| <b>Company</b>    | Trenz Electronic GmbH        |
| <b>PCN Number</b> | PCN-20250704                 |
| <b>Title</b>      | TE0802-02 FTDI EEPROM Update |

### 2.1 #1 FTDI EEPROM content: AMD-Licence key (MISC1)

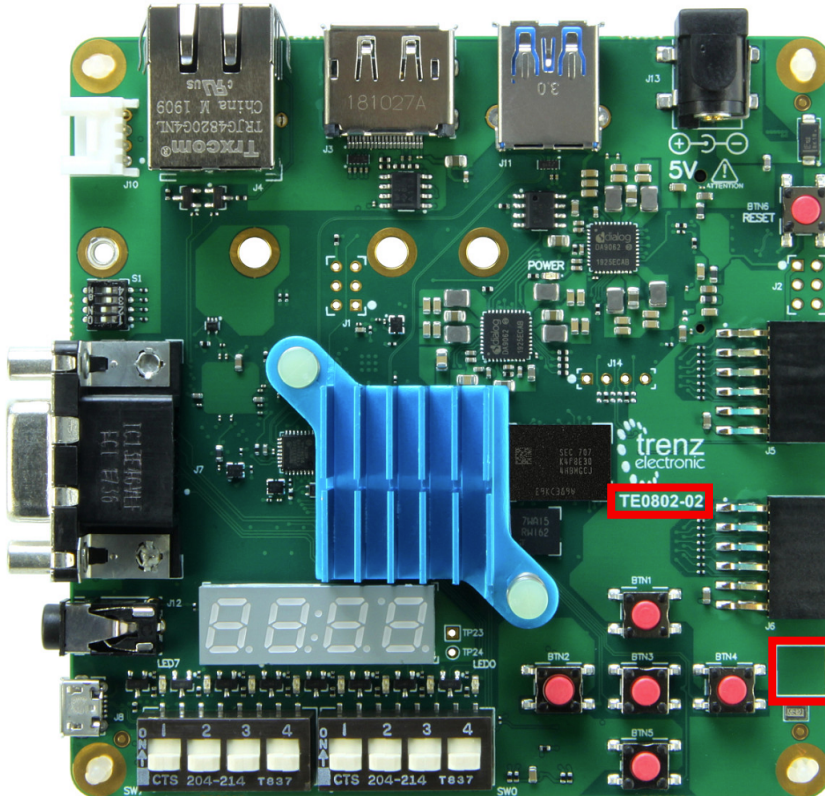
**Type:** Firmware change

**Reason:** Change according to FTDI programming method released by AMD with Tool Version 2022.2 and newer (UG980 - Chapter: Programming FTDI Devices for Vivado Hardware Manager Support).

**Impact:** AMD Licence key is compatible with AMD Tools greater and equal 2017.1 release. Programmer will be identified as Xilinx device with prefix 'TE' ,see [AMD FTDI JTAG Programmer#IdentificationofAMD/TrenzLicence](#)
